Advisory Memorandum

Subject: GERS Correction for General Electric IAC66K Relay

SQUG ADVISORY 2004-01: GERS Correction for General Electric IAC66K Relay

Figure 1 IAC66K Relay Internal Configuration

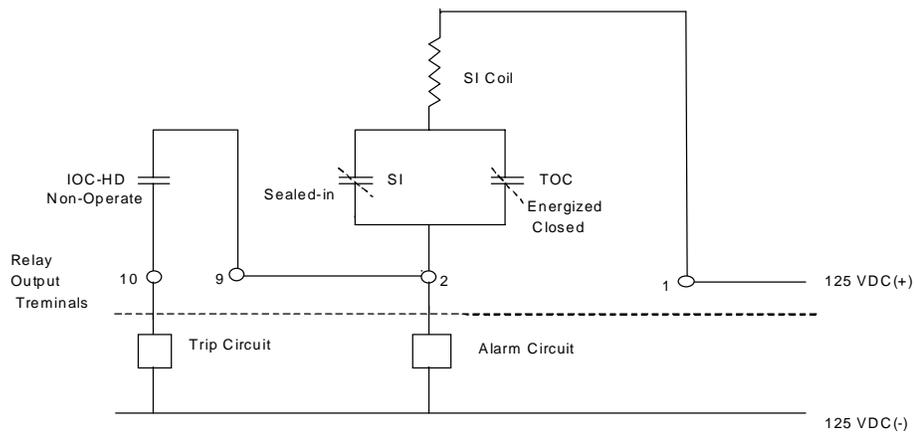
The IAC66K is actually three separate sub-component relays wired together to operate as a system. Each sub-component relay operates at different levels of input AC current to close its respective normally open contact. First, the time overcurrent (TOC) unit is a standard induction disk relay (designated as inverse, long time) that takes several seconds to operate. The TOC unit is set to begin timing operation at a low AC current setting. When this low current setting has been exceeded and the induction disk has finished its rotation, the TOC contact closes which energizes the coil of a target & seal-in (SI) relay, which closes an additional contact that is wired in parallel with the TOC contact. When the SI contact is closed, the SI relay coil is energized by its own contact, and the circuit is said to be sealed-in. The TOC contact can chatter or even open, but the SI contact remains closed. The output of the TOC/SI contact set is used as an alarm indication only. Next, a high dropout instantaneous overcurrent (IOC-HD) relay is set to operate at an intermediate current level. The IOC-HD output contact is wired **in series** with the TOC/SI contact set and connected with the plant DC control circuit for switchgear tripping. Thus, for the series contact pair to have an output, the contacts of **both** units must be closed. If the IOC-HD contact chatters and the TOC/SI contact set is open, then the DC circuit is still open and the chatter cannot affect the switchgear trip circuit. Likewise, chatter of the TOC/SI contact set can only affect the switchgear trip circuit if the IOC-HD contact has simultaneous chatter. If the TOC/SI contact set is sealed-in, then IOC-HD contact chatter can cause spurious switchgear operation. Finally, a separate instantaneous overcurrent (IOC-N) relay is set to operate at a high current. The IOC-N contact is directly connected to the switchgear trip circuit, thus IOC-N contact chatter can directly cause spurious switchgear operation.

The consequences of the GERS typographical error for the IOC-HD subcomponent of the IAC66K will depend upon how the results were utilized in A-46 relay reviews. If the minimum value of 5 g indicated in the GERS report for the TOC/SI unit was used as the non-operate fragility of the relay, then there is no issue concerning the actual lower fragility of the IOC-HD unit being less than 5 g, since the output contacts of the pair of units are connected in series and the non-operate fragility of the series pair is 5 g. However, if the relay evaluation recognized the series contact pair and concluded that the relay fragility in the non-operate mode was governed by the highest fragility level, then the use of the 10 g value erroneously indicated for the IOC-HD would result in an incorrect non-operate fragility for the relay. In this case, the non-operate fragility of 7 g for the separate IOC-N unit would govern. For the operate mode, the 2 g value erroneously indicated for the IOC-HD unit would govern the operate relay fragility in all cases.

The test fragility level for a GE IAC66K relay was established in the Reference report (based on SQUG testing of a model 12IAC66K8A) and was inferred to be the GERS for the IAC66K protective relay model. Subsequent testing of a GE protective relay, model 12IAC66K58A, was conducted by the SQRSTS program with anomalous results. SQUG was contacted to review the SQRSTS test results to ascertain if a conflict with the GERS existed. After review of the SQRSTS data, SQUG recommended retest of the relay with an alternate test monitoring setup. Review of the overall test effort indicated that the observed results were not inconsistent with previous SQUG testing, but rather the behavior that should be expected for an intermediate (alarm) operate state. However, the review of the SQRSTS testing results and the expected operation characteristics of this relay did indicate that the test fragility values reported in the Reference report for the IAC66K subcomponent IOC-HD contact (designated as HDI in the EPRI report) have been interchanged for the non-operate and operate mode. The GERS level for the GE IAC66K relay should be corrected as follows:

IAC66K Sub-Component	Non-operate NO contact	Operate NO contact
	GERS	GERS
TOC/SI [SI/TOC]*	5	10
IOC-HD [HDI]*	10 2	2 10
IOC-N [STDI]*	7	7

Figure 1. Alternate Output Monitoring Circuit

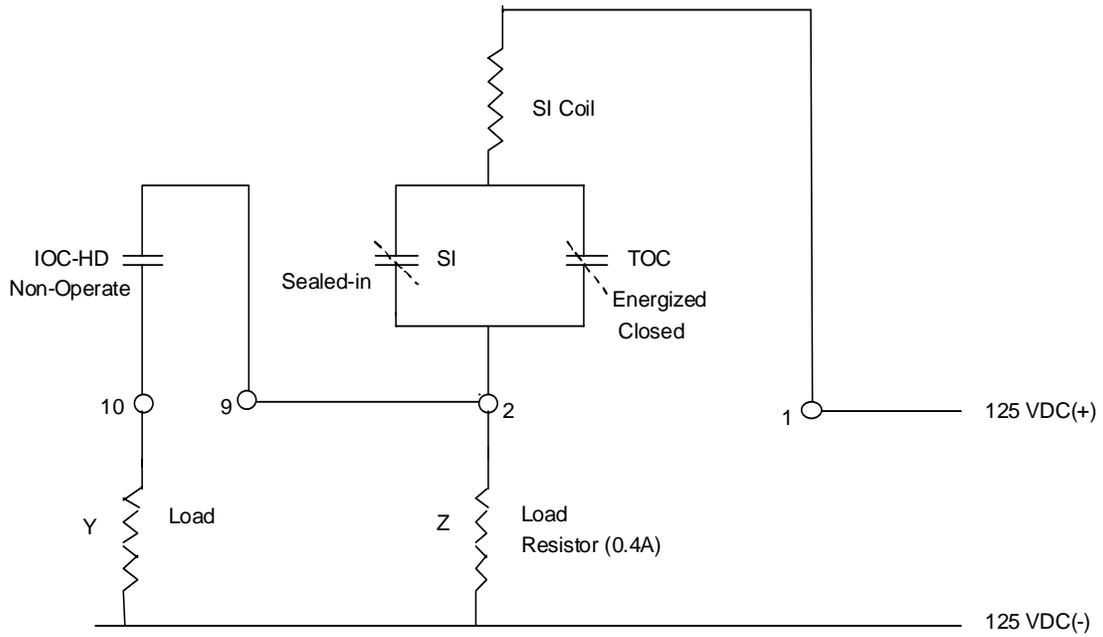
The procedure that was used in the SQUG relay testing program (Reference 2), in the case of protective relays, was to test each relay sub-component as a separate device. For the DC output circuit, the contacts of each relay were separately monitored for chatter. The alternate output monitoring circuit, shown in Figure 1, was used in the SQRSTS testing of the IAC66K. In this wiring setup, the TOC/SI (terminals 1-2) and IOC-HD (terminals 2-10) contacts are wired in series to reflect how the relay is actually used rather than monitoring each contact set individually (which requires a change of internal relay wiring).

For the operate mode tests, the SQRSTS testing was conducted with the relay input at 200% pull-in current of the TOC/SI, but this input current level was only approximately 75% of the pull-in of the IOC-HD, thus the IOC-HD was actually in the non-operate mode. Thus, the operate mode testing was actually conducted in the alarm state with the TOC/SI operated (and sealed-in), and with the IOC-HD in a non-operate mode. This is the contact state indicated in Figure 1. As can be noted in Figure 1, the IOC-HD is free to chatter which led to the anomalous results observed during the testing. The contact monitor indicated chatter on both the TOC/SI and IOC-HD contacts for low test input levels. Since the TOC/SI unit had operated and sealed-in, this behavior indicates that IOC-HD was chattering at a very low motion level. The apparent chatter noted on the TOC/SI is not actually a chatter, but instead a current fluctuation due to the IOC-HD loop of the monitoring circuit going in and out of the circuit when the IOC-HD contact chatters (see Figure 1). Thus, the test results are actually for the IOC-HD contact in the non-operate mode.

Based on the data available, it is judged that the fragility levels of the IOC-HD sub-component of the IAC66K is slightly greater than 2 g (4-16 Hz range) in the non-operate mode. Based on SQUG testing experience, relays designated as “high dropout” units (i.e., drop out with only a small decrease in voltage or current) tend to have low ruggedness for the normally open contact. Therefore, a conservative value of 2 g is used. It is judged that the fragility levels of the TOC/SI units are greater than 5 g (4-16 Hz range) in the non-operate mode. Based on a review of the available test data, it is apparent that the non-operate and operate GERS levels for the IOC-HD [HDI] given in Reference 1 should be interchanged to indicate that non-operate fragility level is 2 g and that the operate level is 10 g.
